Access Compliance Report

Public Rights-of-Way

(Curb Ramps)

Intersection ID: 16121	Main Street: APPLEWOOD_LN	Cross Street: CHESTNUT_LAKE_DR	Location: NW
ADA ID: 8252CEDCBA09	Ramp Type: Directional1	Initial Pass/Fail: Fail	Overall Compliance: No
			Severity Score: 33.75

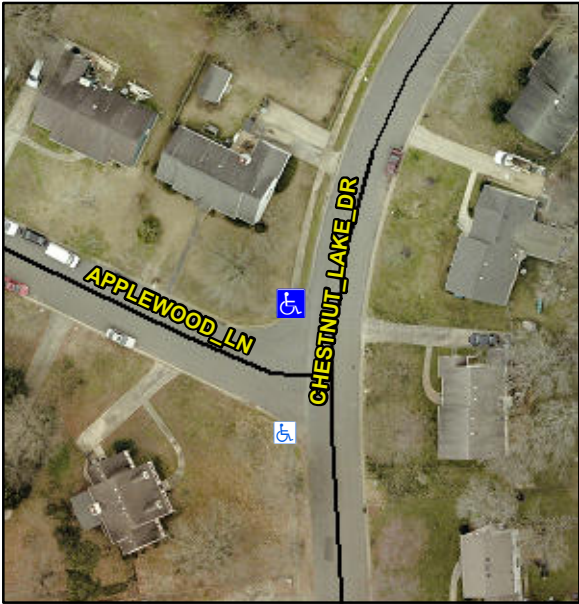
Codes/Mitigation Info/Possible Solution			Field Measurements/Component Compliance					
 <p>Street 1 Name APPLEWOOD LN</p> <p>Stop Condition-Street 1 StopSign</p> <p>Street 2 Name N/A</p> <p>Stop Condition-Street 2 N/A</p>	Possible Solutions:		Compliance	Description	Data	Compliance	Description	Data
	Remove & Replace Entire Ramp.		N/A	Ramp Length (in)	62.0	N/A	Grade Break?	N/A
			No	Ramp Width (in)	46.5	N/A	Grade Break Slope (%)	0.0
			Yes	Ramp Slope (%)	6.3	N/A	Grade Break XSlope (%)	0.0
			No	Ramp XSlope (%)	11.0			
			N/A	Flare Type LT	N/A	N/A	Flare Type RT	N/A
			N/A	Flare Slope LT (%)	N/A	N/A	Flare Slope RT (%)	0.0
			N/A	Flare Traversable LT?	N/A	N/A	Flare Traversable RT?	N/A
	Surveyor Notes:		N/A	Landing Length (in)	0.0	N/A	DWS Provided?	N/A
				Landing Width (in)	0.0	N/A	DWS Contrast?	N/A
			Landing Slope (%)	0.0	N/A	DWS Length (in)	N/A	
			Landing X Slope (%)	0.0	N/A	DWS Full Width?	N/A	
PROW/ADA:			Landing Curb? (Y/N)	N/A	N/A	DWS Offset LT (in)	N/A

R304.5.1, R304.5.3			Shared Landing?	N/A	N/A	DWS Offset RT (in)	N/A	
			Gutter Ponding?	0.0	N/A	Gutter Slope (%)	N/A	
			Gutter Lip Ht (in)	0.0	N/A	Gutter X Slope (%)	N/A	
			Painted X Walk1?	No		Road Slope (%)	2.7	
			X Walk 1 Direction	To S		Road X Slope (%)	3.2	
			X Walk 1 Width (in)	N/A		Clear Space?	N/A	
			X Walk 1 Slope (%)	2.7	N/A	Clear Space to XWalk (in)	N/A	
			X Walk 1 X Slope (%)	3.2	N/A	Storm Grate/Utility Hazard?	N/A	
			Ramp inside XWalk1?	N/A		Storm Grate/Utility Type		
			Any Obstructions?	N/A			N/A	
			Obstruction Type		Yes	Surface Condition? (G/P)	Good	
					N/A	Curb Slope (%)	20.5	
Total Cost:		\$ 1600.00
